**I-405 MP 26.46 North Fork Perry Creek
(WDFW ID 08.0070 A 0.25):
Final Hydraulic Design Report – NDC 152**

Revision		Description
A	4/5/2024	Preliminary Submittal
B	8/25/2024	Final Submittal
0	4/9/2025	RFC Submittal
1	5/1/2026	NDC 152

This notice of design change (NDC) modifies the I-405 MP 26.46 North Fork Perry Creek Final Hydraulic Design Report (FHD). It presents updated bed material gradations and updated scour analyses associated with this change. This report addendum supersedes and replaces the following tables, sections, and figures as specified below.

Figure 4-2: Design riffle cross section

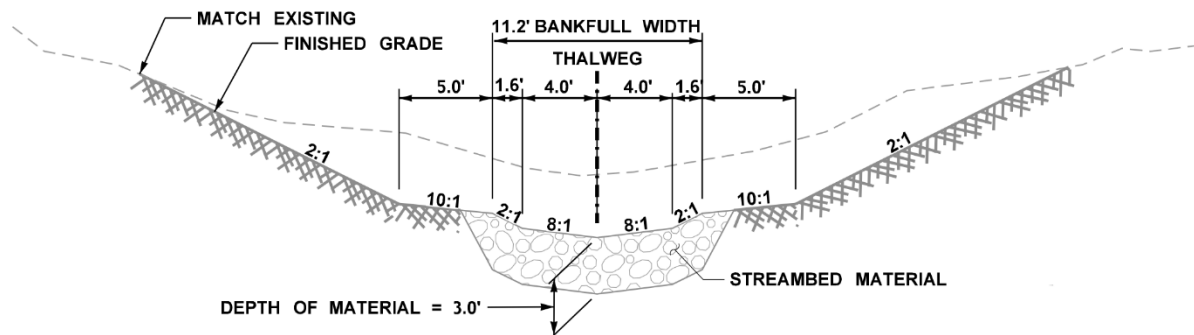
- Section 4.1.1 Channel Planform and Shape
 - Removed reference to previous Type I Streambed Material in text
 - Updated Figure 4-2 and Figure 4-3
- Section 4.2 Minimum Hydraulic Opening

Proposed cross slopes in riffles are 8H:1V to promote fish passage in low flows. Per stability recommendation from the geotechnical engineer, proposed riffle cross sections have 2H:1V bank slopes rising to the BFW of 11.2 feet (**Figure 4-2**).

Figure 4-3: Design pool cross section

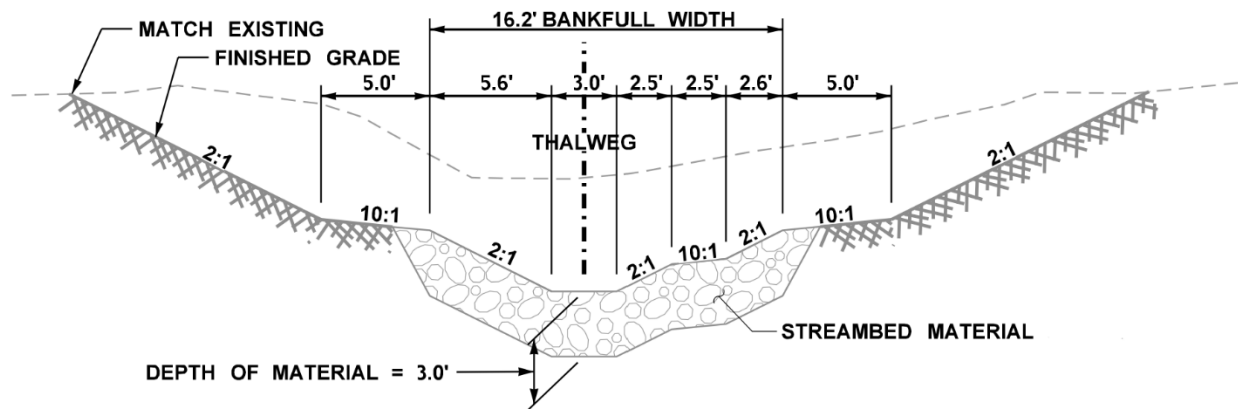
The proposed typical pool section (**Figure 4-3**) has a wider BFW of 16.2 feet, necessary to achieve an acceptable residual pool depth of 1.5 feet and to accommodate the maximum 2H:1V bank slopes. Typical pools are pre-scoured and considered starter pools. They are expected to scour more over time as indicated by bend scour calculations in **Section 7.4.3**. Typical pool sections also include a 10H:1V bench on the inside of meander bends to mimic the formation of point bars (Cramer 2012).

Figure 4-4: Minimum hydraulic opening illustration

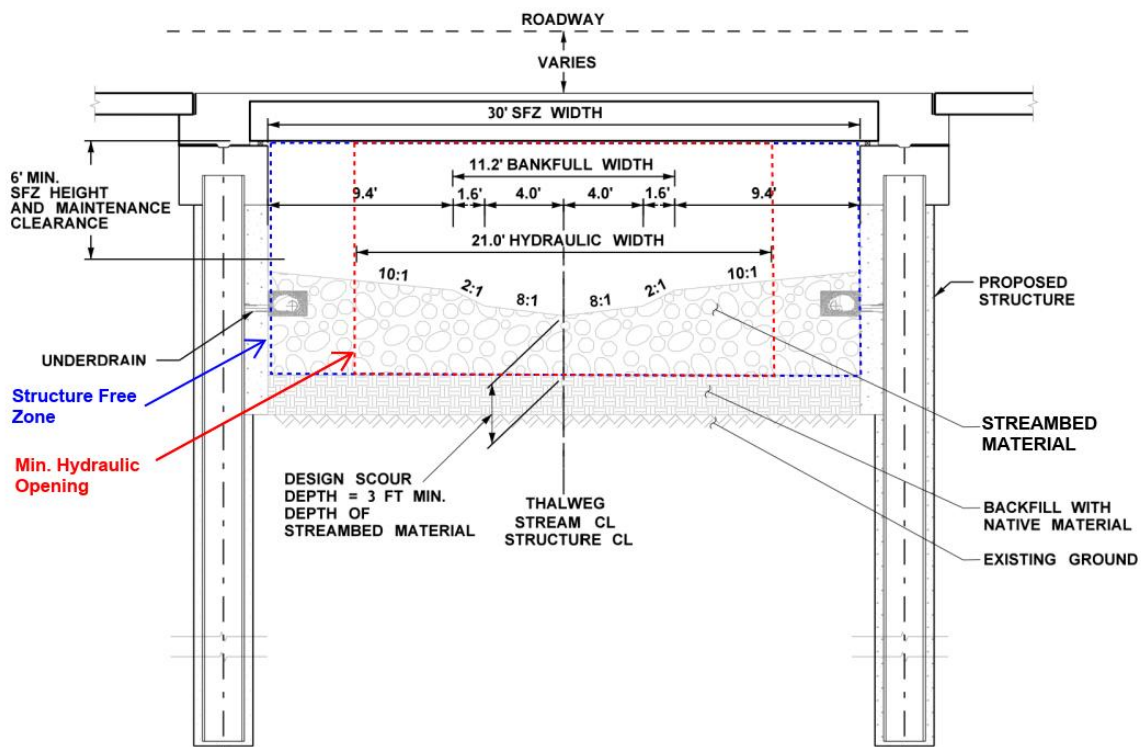
- Updated Figure 4-4
- Section 4.3.1 Bed Material
 - Updated discussion of streambed material gradations
 - Updated Table 4-1 and Table 4-2
 - Table 4-7 deleted
